Re: Draft Cleanup and Abatement Order, Recology Hay Road

We provide these comments on behalf of Recology Hay Road (RHR) on the Draft Cleanup and Abatement Order (Order R5-2014-XXXX) issued on May 7, 2014. RHR and its technical consultants have had a relatively short time to digest and respond to the voluminous Draft CAO, which is 84 pages in length, contains 91 findings, and proposes a detailed, diverse and extensive array of requirements spanning 10 pages of text. Despite the severe time limitations, RHR and its consultants have prepared itemized responses to the specific findings and provisions of the Draft CAO, which are presented in the attached Technical Appendix. As more information is developed, RHR may supplement these comments.

Finding #13

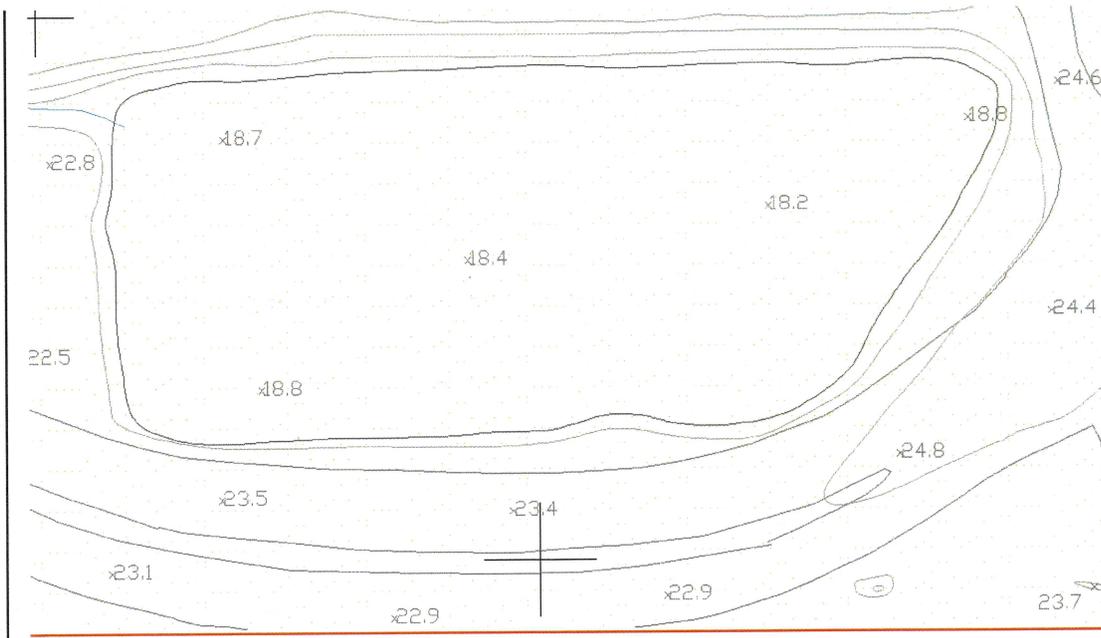
See Response #12. There is no discharge to surface waters from the lined pond system; such a discharge has never occurred and it is not allowed to occur.

Finding #31

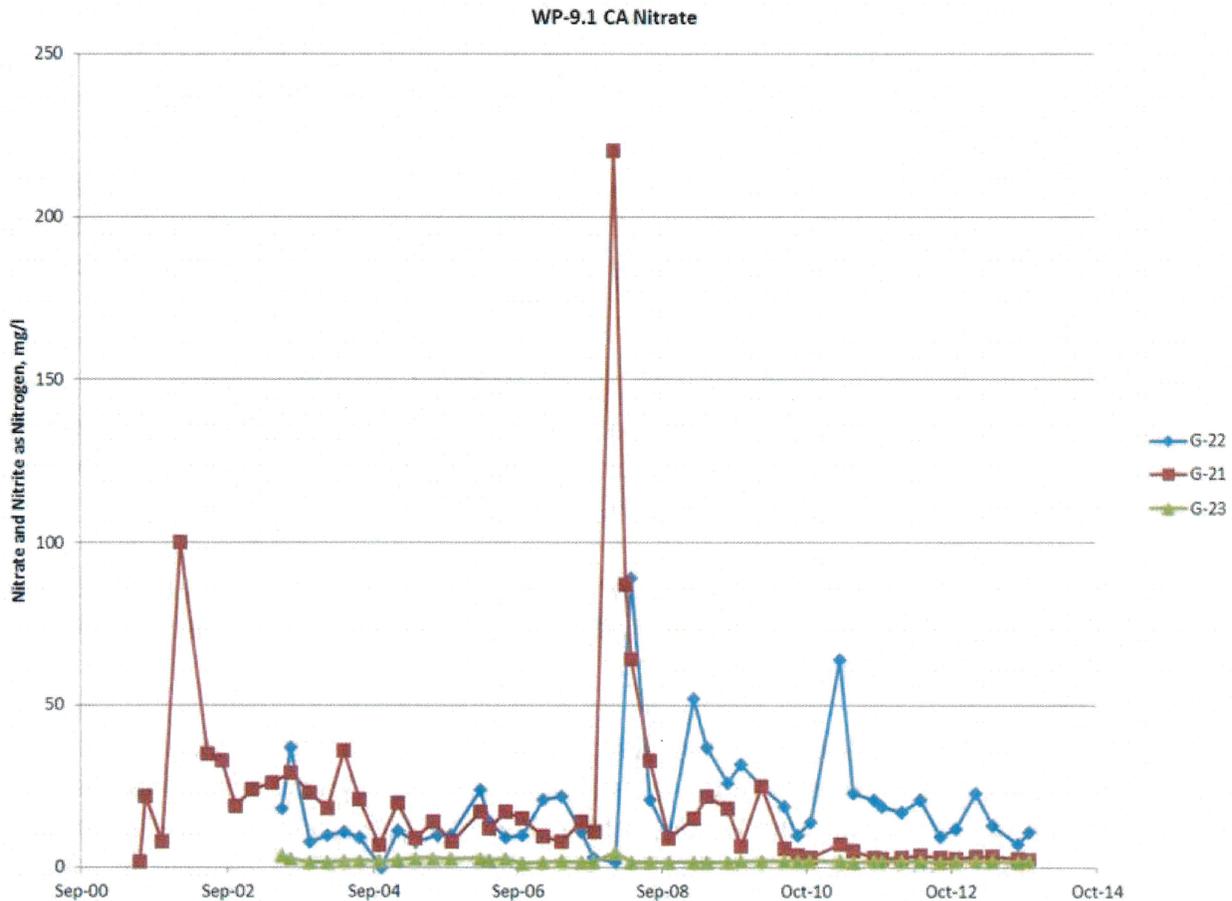
For clarity, use of the term “leachate” for describing compost contact water should be changed to “compost leachate” to distinguish it from landfill leachate.

Reference Footnote #8 that states that “the storage of finished product in this area and the collection of leachate in the high-flow pond are both violations of the WDRs” is incorrect. WDR Finding #88 states that “an additional 32 acres is used to store finished compost product.” As previously stated in the response to CAO Finding #10, all finished product has been stored within the permitted 54-acre boundary. In regards to the high-flow pond contents, the 2006 pond design approval recognizes that the high-flow pond will contain runoff from the active composting area which is understood to contain both compost leachate and stormwater. Finally, modifications to the low-flow pond were

submitted to the CVRWQCB on September 17, 2010. These drawings included a pump and piping system to pump aerated liquid from the low-flow pond to the high-flow pond. In light of these circumstances, we do not agree with the alleged violations and request that Reference Footnote #8 be deleted in its entirety.

Finding #34

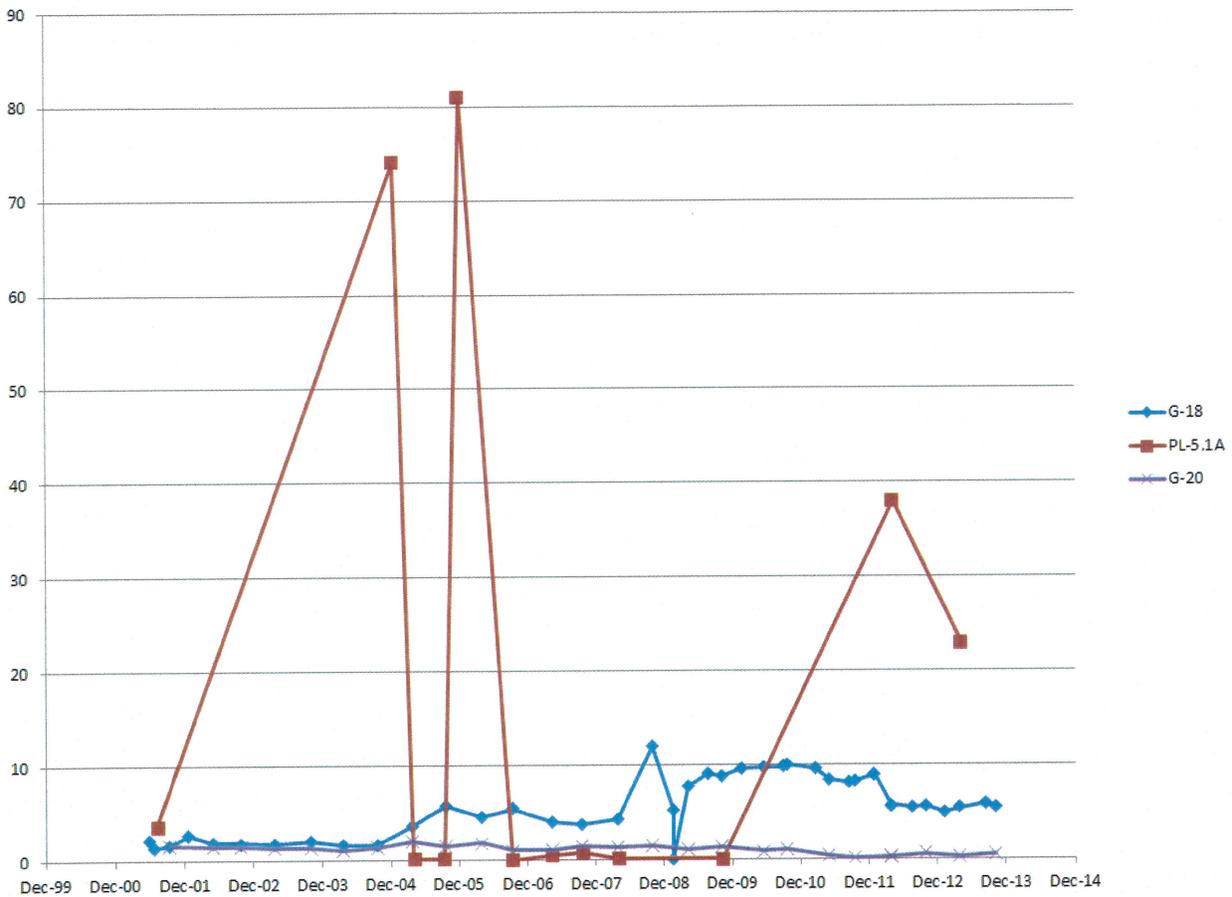
The reference to the initial nitrate concentration detected in background monitoring well G-18 of <0.06 mg/L on 6 June 2001 is incorrect. The initial sample from G-18 was collected on 27 June 2001 and revealed a nitrate concentration of 2.2 mg/L. In regards to the statement that inclusion of analytical data beyond 2004 is not appropriate, we disagree with this statement on the basis that there was not a statistically significant upward trend in G-18 until the second half of 2006 and the slightly higher nitrate concentrations in G-18 were similar in range to those in another upgradient background monitoring well (G-17), which had been as high as 3.7 mg/L in the same time period. Thus, using the 2006 concentration limit was statistically valid, rather than going back to 2004. Based on the valid nature of this statistical approach, Finding #34 should be deleted.

Finding #38

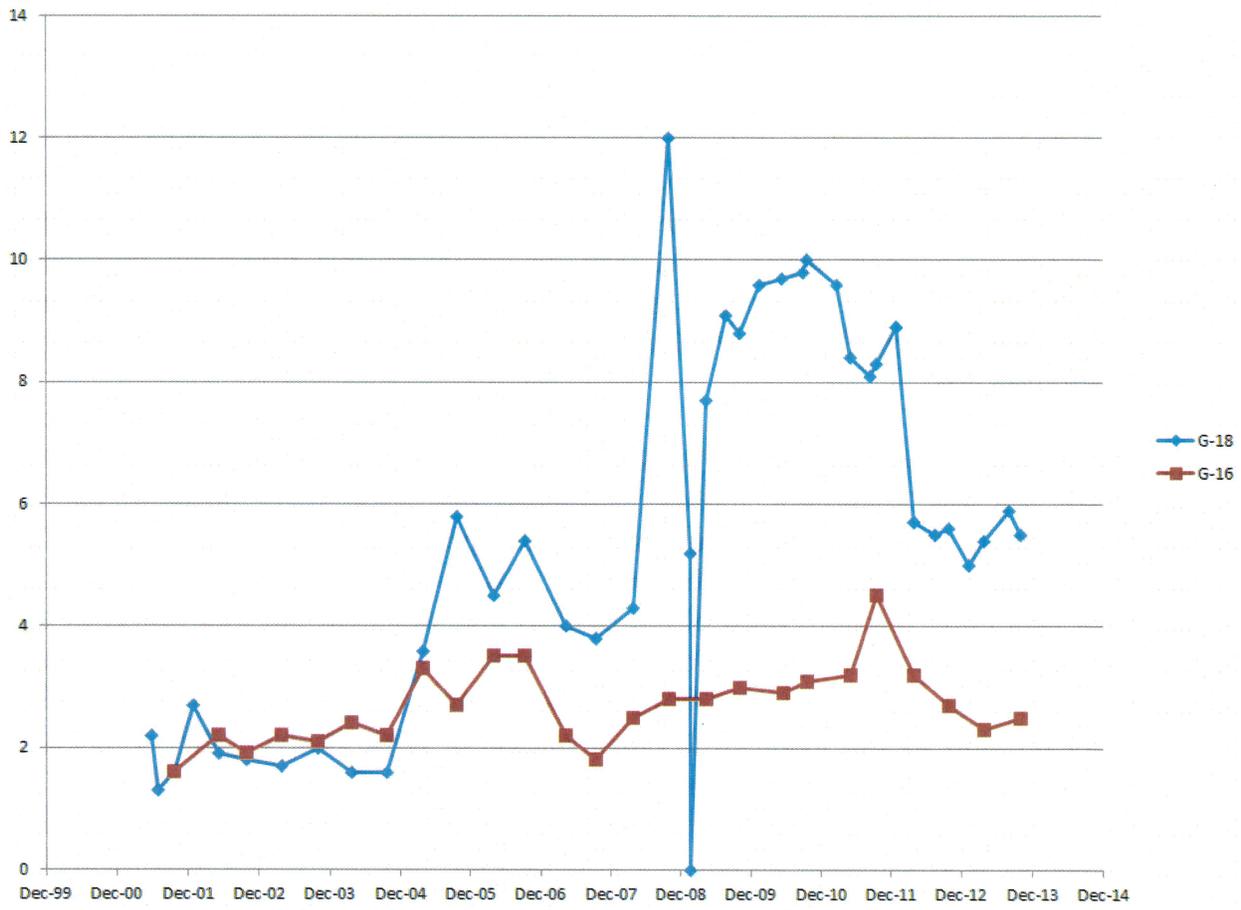
From an overall perspective, it is important to emphasize that the nitrate conditions at the site are comprised of distinct localized areas associated with different sources and do not represent a single nitrate plume as stated in this finding. As presented in Golder's March 12, 2014 letter report submitted to the CVRWQCB, there are currently three nitrate-impacted groundwater areas at the site; (1) Waste Pile 9.1 corrective action area; (2) western site area encompassing well 4BR, and (3) eastern site area adjacent to DM-6.2 and DM-4.3. These are three separate plumes and should not be collectively grouped because such an interpretation implies a much larger area of impact than is actually present. It should also be emphasized that each of the individual plumes is restricted to the interior of the site and have not impacted downgradient perimeter monitoring wells.

In regards to specific statements outlined in this finding, in the case of G-22, this extraction well was installed to address the release from WP-9.1, and as previously discussed in our response to Finding #32, has shown progress in reducing nitrate concentrations to levels near the concentration limit. Nitrate in the area of monitoring well G-4R, in turn, was related to a different source, overflow from the ditch at the compost area, which has been corrected. Similarly, nitrate in the area of monitoring wells G-14 and G-31 was associated with the dried sludge stockpile, which has been removed. As such, the statement referring to a single nitrate plume is not
